## **Village of Biscayne Park Commission Agenda Report**

**Subject:** Draft of Proposed Code Changes  
to Chapter 5.

MEMORANDUM

**RE:** Chapter 5 Revisions

Clear Visibility Triangle at Road Intersections  
Diagram 5.4.1 (a)

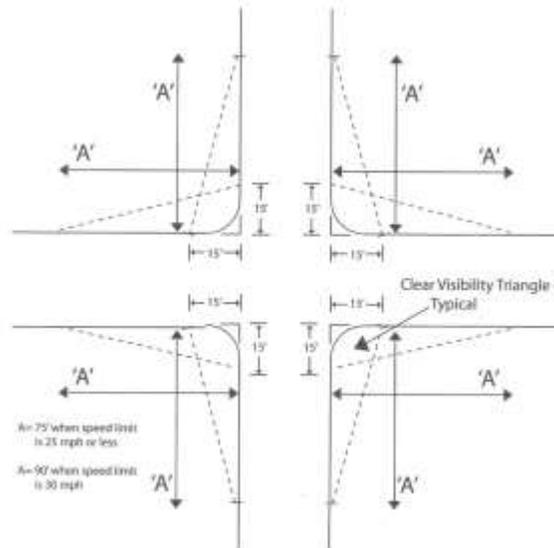
Code Review: No change in language, only a better graphic provided.

Parks & Parkway: Clarify language that goes with the diagrams. Ask County Public Works to review. Also, is 15' allowed for driveway visibility?

(a)(b) For street intersections the clear visibility triangle shall be formed by connecting points on the edge of each street and the intersection point. Beginning at point one, the intersection, point two shall be located Fifteen (15) feet from the intersection on one street and point three on the second street shall be located at a distance from the intersection, measured in feet equal to ~~F~~three (3) times the streets speed limit. A line connecting the three points shall create the triangle. This triangle applies to both directions from the intersection. See Diagram 5.4.1 (a)
